RE: TEDS Exception No. 25-03, for Access Spacing at 584 North Commercial Drive

**DESIGN EXCEPTION #DE25-03**

RE: Exception for Access Spacing at 584 North Commercial Drive

## REQUEST FOR TEDS EXCEPTION

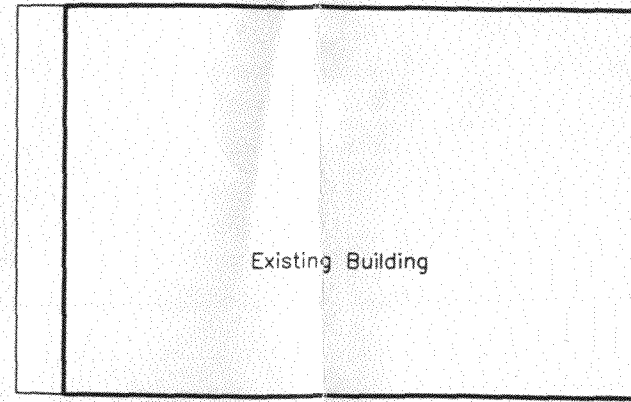
Per Chapter 14 of the City of Grand Junction Transportation Engineering Design Standards, we are requesting a one-time, single-location, exception to the TEDS for the driveway on the above referenced project. The standard (Section 4.1.1 and 2) calls for the spacing between adjacent commercial driveways to be at least 50 ft apart and for them to line up with opposite accesses or be offset by 150 ft. The project is currently in site plan review for construction of an office/storage building for the petitioner. The driveway as shown on the current plan is located 59 ft from the adjacent driveway to the north and over 100 ft from the adjacent driveway to the south. There are two driveways opposite the proposed driveway that do not line up. Due to the narrow lot frontage of the proposed development and the noncompliance of the existing opposite driveways, it is not possible to line up the proposed driveway. Traffic volume on North Commercial Drive is very low, thus, there should be minimal impacts from non-conforming driveway.

There is no possibility for an alternative shared driveway to the north. The site to the north is already developed and there is a building along the south property boundary making it impossible to share a driveway on the north. The property on the south is currently vacant but will be developed in the near future. A cross access agreement has been made between the two property owners which will help the access issue in the future by providing circulation all the way around the proposed building.

The proposed design is shown on the site plan currently under review by the City Community Development Department. The impacts of this proposed TEDS exception should be minimal due to the low traffic volume on North Commercial Drive and the low volume of traffic that accesses the existing conflicting driveways to the west. Please consider this exception and let us know your decision at your earliest convenience.
